From: d'Almeida, Carolyn K. [/O=EXCHANGELABS/OU=EXCHANGE ADMINISTRATIVE GROUP (FYDIBOHF23SPDLT)/CN=RECIPIENTS/CN=9EC4401AFA1846DD93D52A0DDA973581-CDALMEID]
Sent: 6/22/2017 11:26:17 PM
To: Bo Stewart [Bo@praxis-enviro.com]; Jennings, Eleanor [Eleanor.Jennings@parsons.com]; Cosler, Doug [Doug.Cosler@TechLawInc.com]; Davis, Eva [Davis.Eva@epa.gov]; Dan Pope [DPope@css-inc.com]; Wayne Miller [Miller.Wayne@azdeq.gov]; Steve Willis [steve@uxopro.com]
CC: Brasaemle, Karla [Karla.Brasaemle@TechLawInc.com]
Subject: RE: Williams - ST012 - Period ending 5/12 report

Subject: Williams - ST012 - Period ending 5/12 report

Please find attached for your information the preliminary report describing ST012 activities for the period from April 29 thru May 12, 2017.

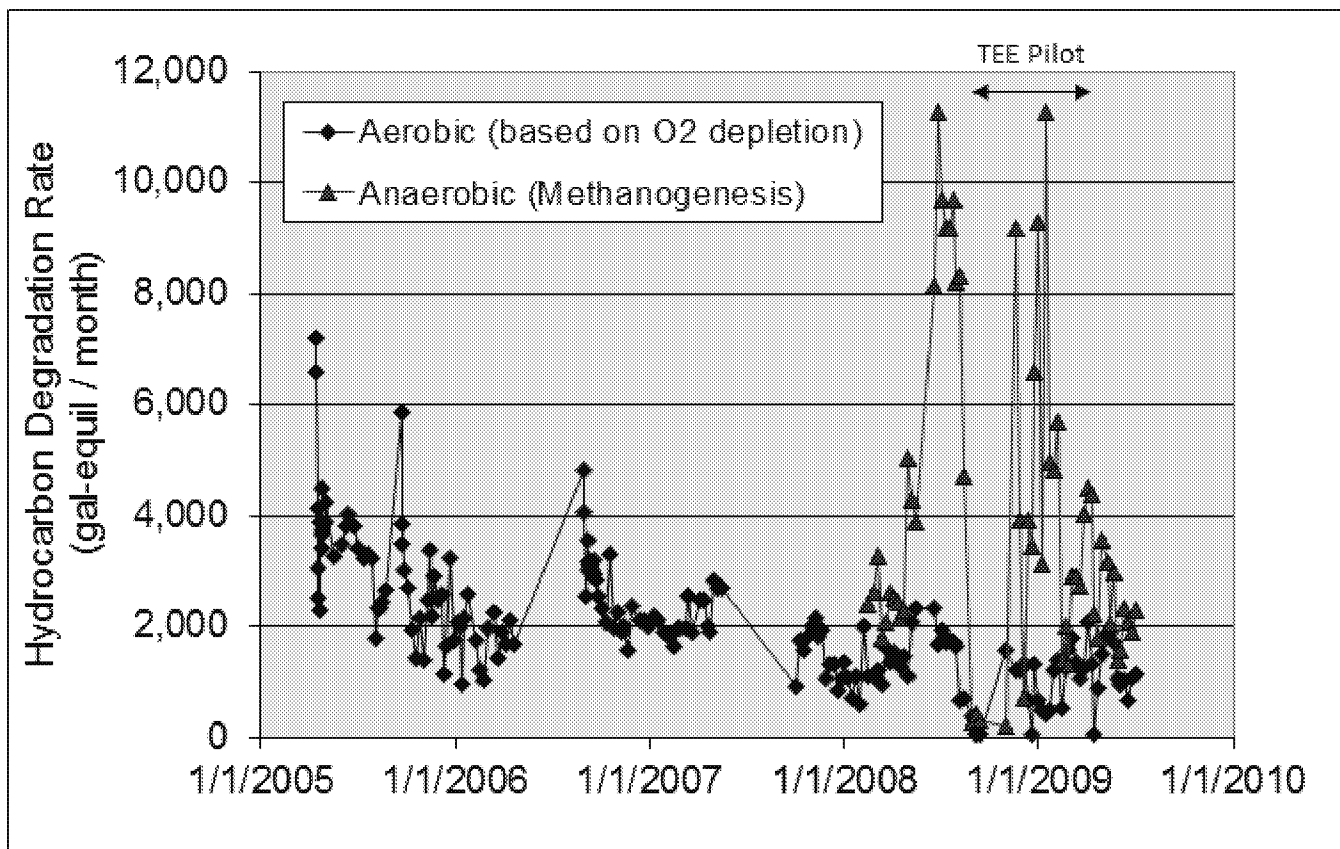
“A similar decay in methanogenesis was observed after steam injection ceased.” Why???

That's why they made the effort today to demonstrate how much methane they are pulling out as evidence that biodegradation is occurring. But I still think the key question is why is the trend in methane production declining from initial record right after SVE startup. Does this represent methane production from decades of biodegradation before SEE which they just now recovered, and is tapering off as it is extracted, and maybe does not reflect current biological conditions?

Here are the similarly calculated rates of degradation from SVE operations starting in 2005 and through the TEE pilot test from manifold data. The SVE manifold is a mix of extraction wells including the middle vadose zone (likely aerobic) and the deep vadose zone (very likely anaerobic). Measures from individual extraction wells are available to sort out where the degradation was occurring. A similar decay in methanogenesis was observed after steam injection ceased.
